AC 20-140C – Comment Matrix

Originating Office: AIR-130	Document Description: Guidelines for Design Approval of Aircraft Data Link Communication Systems Supporting Air Traffic Services (ATS)	Project Lead/Reviewer	Reviewing Office:	Date of Review:
---------------------------------------	--	------------------------------	--------------------------	------------------------

Suggested figure to replace Figure 1 in AC 2-140 (note criteria shown is based on important notes in table, and need to be validated by peer review).

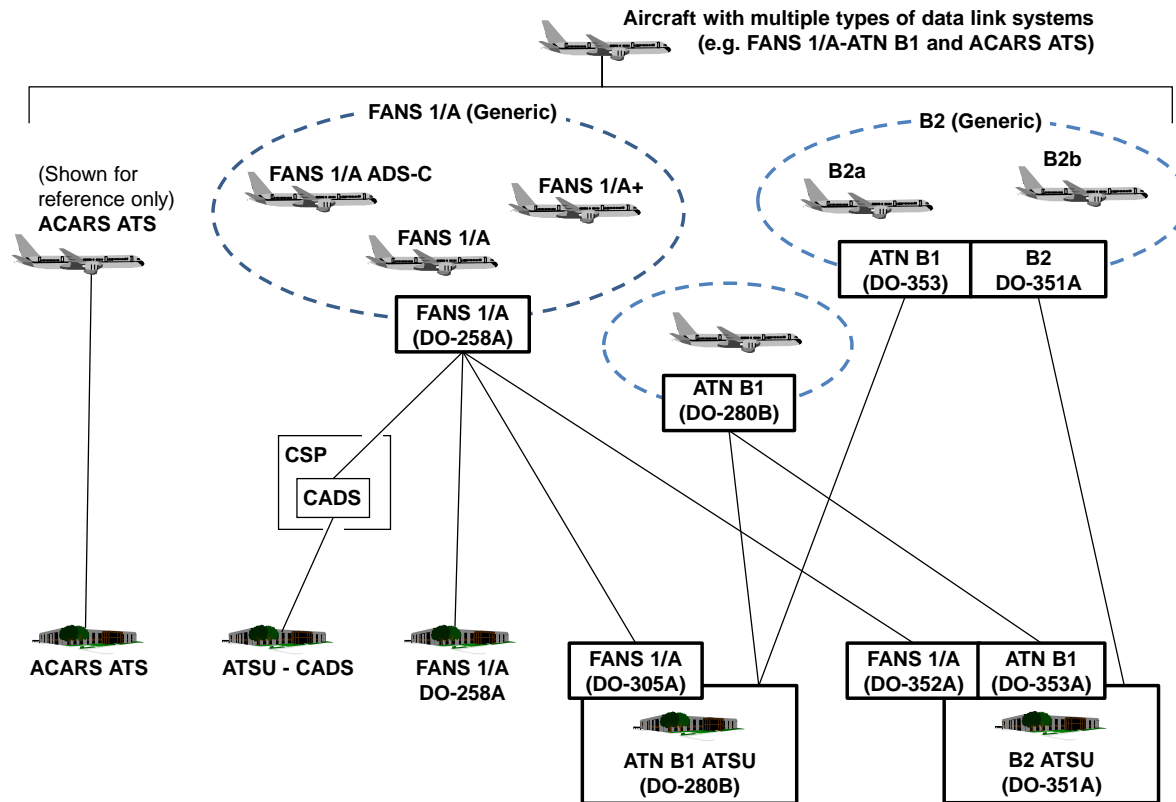
31.	TKraft	5.2.2 Figure 1 (graphic)	Important notes in the table underneath Figure 1 are lost in the graphic and the interoperability designators now no longer mean anything since they are the same designator with different interoperability requirements. Suggest modifying figure to annotate the additional requirements for aircraft or	Revise the graphic so that a unique interoperability designator (or designation) is associated with a different capable aircraft or ATSU data link system . See 2 new figures suggested at the end of this comment metric.	Disagree. Interoperability is not dependent on any of the Notes indicated in Fig 1. Seamless transition and accommodation of data communications between different Interop Designators are discussed in the

Commenter	Section # and Page #	Comment	Suggested Change and Rationale	Disposition
			ground system, as appropriate.		Notes that are provided in Fig 1. Unique Interop Designators for each of these situations is unwarranted and will increase the number of designators to an operationally unacceptable number.
